Vernon Schmidt  
Builders FirstSource  
Aberdeen/Southern Pines/Fayetteville, NC

Per information you provided, I understand there is concern regarding bottom flange nailing in Boise Cascade BCI® joists at the subject project.

Lot 4 Ila's Way  
82 Boston River Drive  
Dunn, NC

Figure 2: Simpson StrongTie IUS hanger information

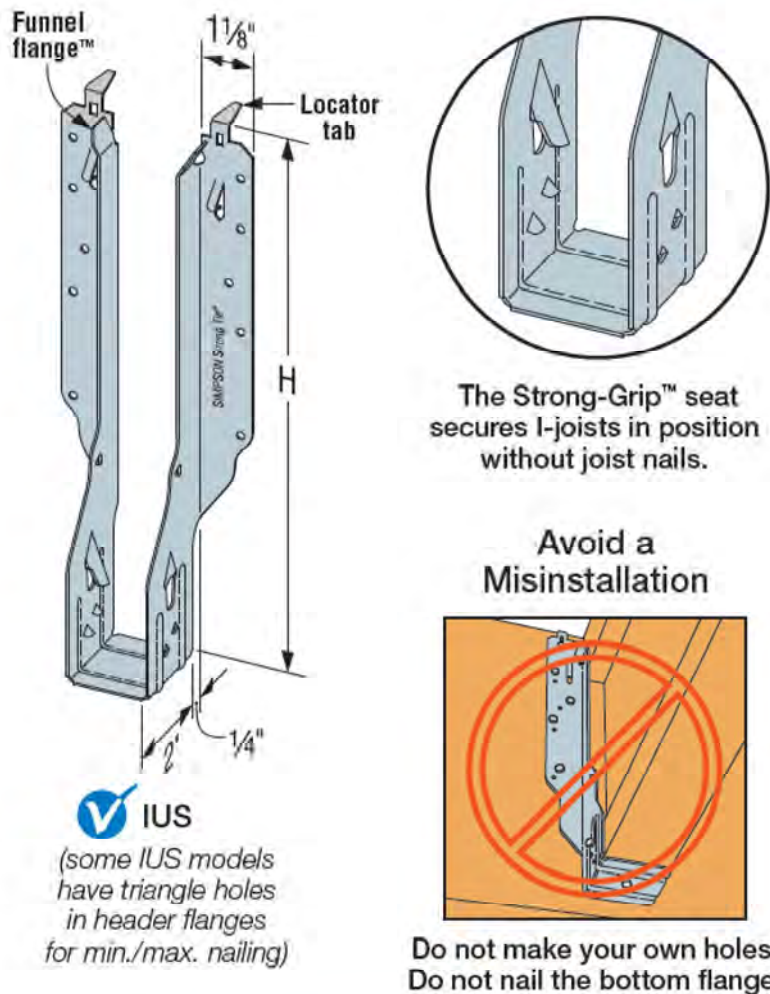
Simpson IU1.81/14 hangers have been installed to support one end of the above joists. The IUS hangers do not require nails in the joist as shown in figure 2 and attached page 144 from Simpson Strong-Tie Wood Construction Connectors 2024-2025 C-C-2024 catalog.

Image 5: Bottom flange nailing in 14" BCI® 4500s joists, provided by Builders FirstSource

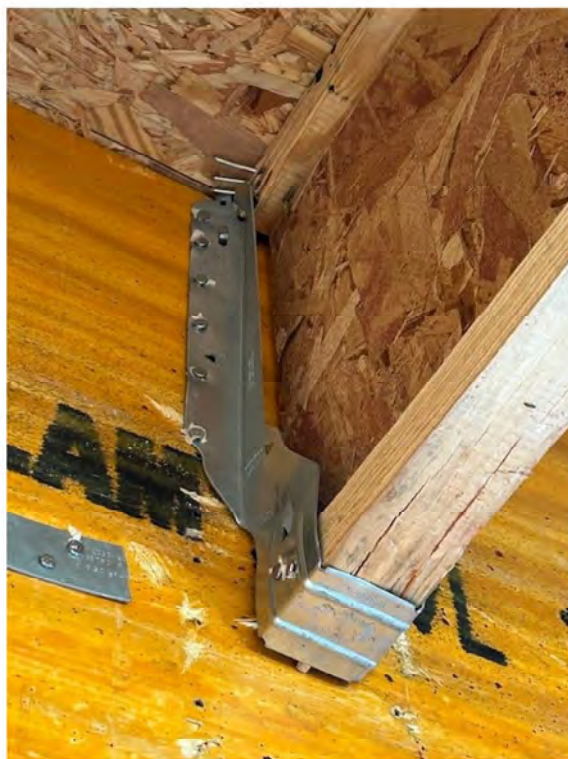
Nails have been driven through the sides of the hangers into the bottom flanges as shown in images 1-6.

No repair is required for the joists listed above with flange splitting that does not exceed a maximum length of 3" measured from the inside face of the hanger.

Joists listed above with flange splitting exceeding 3" up to a maximum length of 12" measured from the inside face of the hanger shall be reinforced per the attached repair detail.
